Attachment A

Response to USEPA Comment No. 1d from letter dated December 3, 2019

As a follow-up to a conference call with United States Environmental Protection Agency (USEPA) Region 9 on December 20, 2019, Panoche Energy Center (PEC) has prepared the following response to Comment No. 1d from the letter provided by USEPA Region 9 dated December 3, 2019. As stated in PEC's e-mail dated December 20, 2019, PEC's planned response to Comment 1d would generally focus on the following four points:

Figure C-16 (New)

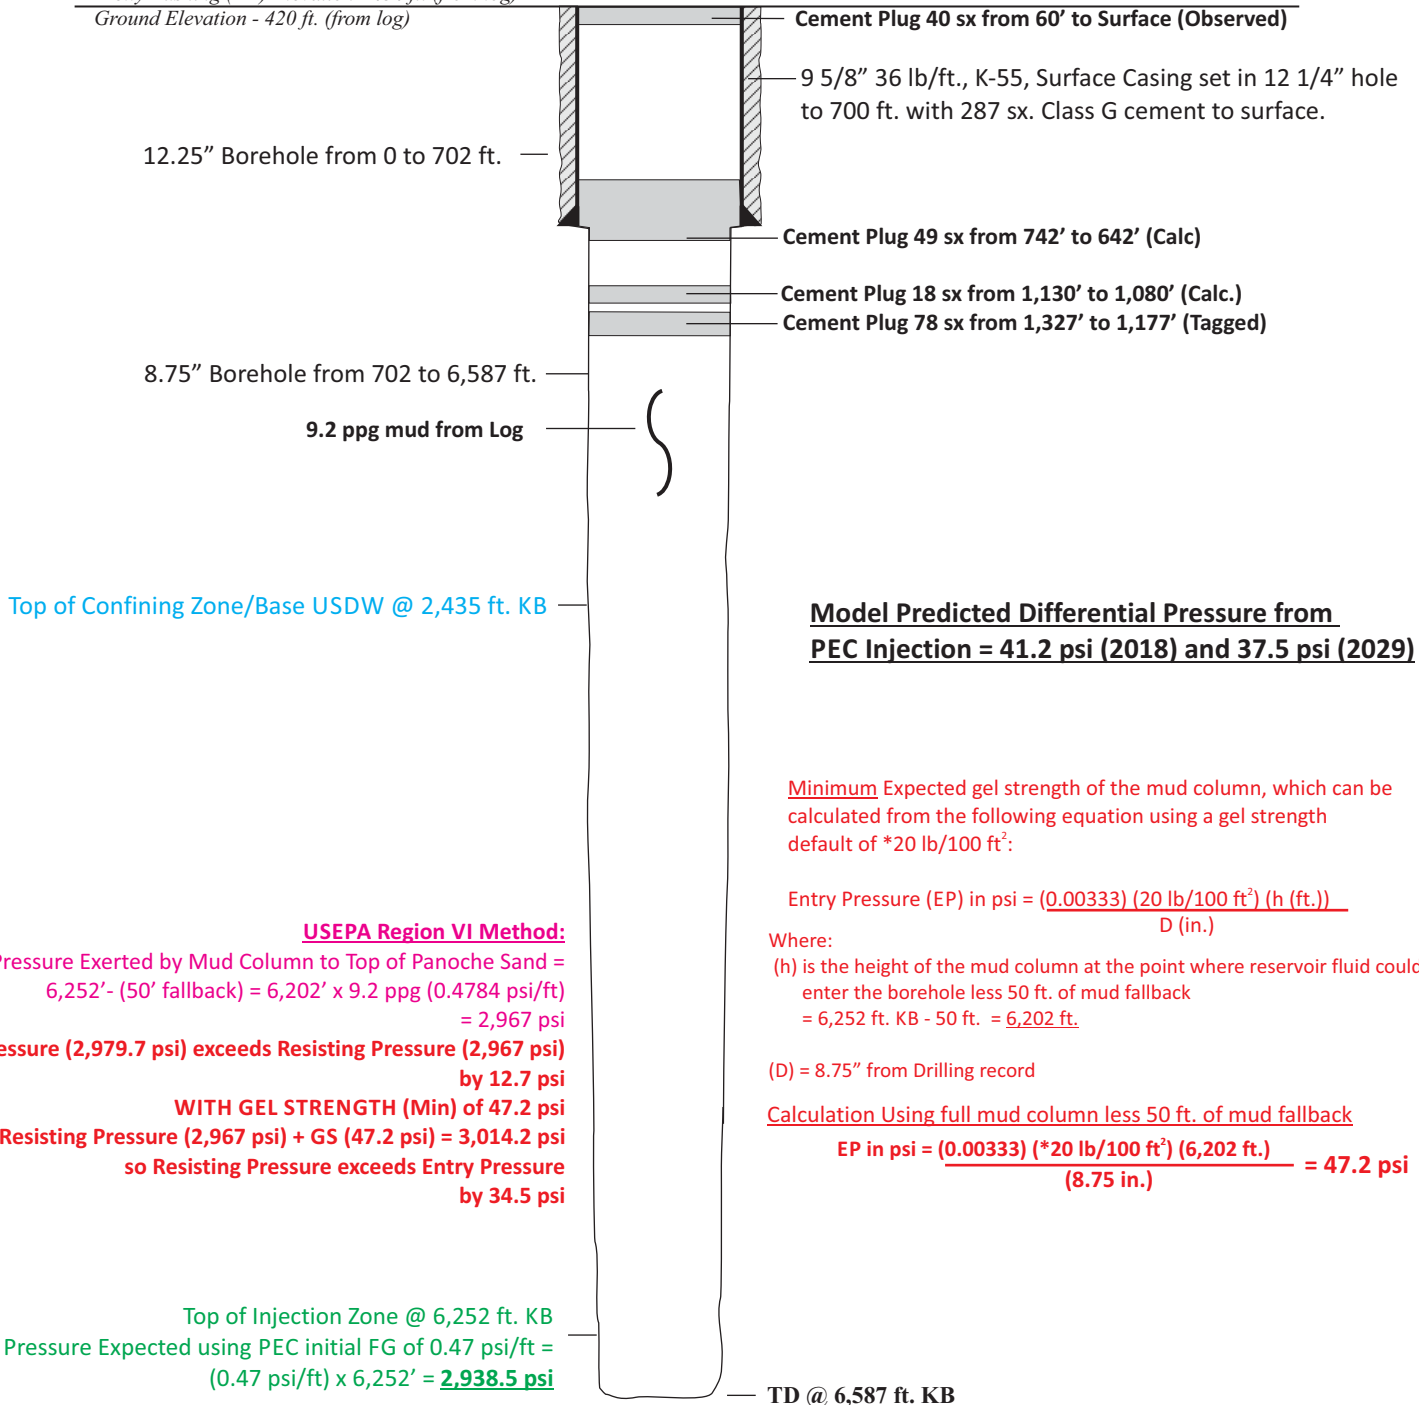
As shown in the well schematic in Attachment A-2 for Souza No. 2 (Figure No. C-16), this well was a dry hole drilled in 1985 to a depth of 6,587 feet below kelly busing level (KB). Surface casing was set to 700 feet KB and cemented to surface. No longstring casing was set in this well. Cement plugs were set in 1985 from 1,327 to 1,177 feet KB, 1,130 to 1,080 feet KB, 742 to 642 feet KB, and a surface plug from 60 feet KB to ground level. However, as mentioned above, no cement plug was set between the top of the injection zone and the base of the USDW (bottom depth of 2,435 KB), and relatively light drilling mud (9.2 pounds per gallon) was left in the borehole based on the open-hole log information. As discussed above in Section 2.2, if mud gel strength is included as part of the corrective action evaluation protocol, then the hydrostatic head of the fluid column at Souza No. 2 exceeds the calculated borehole entry pressure by at least 34.5 psi and this location passes the USEPA Region 6 protocol. However, if mud gel strength is removed as a consideration, then the mud column hydrostatic head is 13 psi less than the calculated borehole entry pressure at this location.

If corrective action at Souza No. 2 is needed, then we recommend an iterative approach where the mud sampling is attempted followed by plugging. This will address both Focus Points No. 2 and 3 listed above in Section 1.1. The general procedure for mud sampling and plugging would be as follows:

7. Following completion of logging, circulate heavy drilling mud to surface.
8. Spot a balanced cement plug from 6,252 to 5,900 feet KB across the top of the injection zone. Wait on cement.

9. Tag cement top and then spot a second balanced cement plug from 2,600 to 2,300 feet KB across the upper confining zone and lowermost USDW contact interval. Wait on cement.
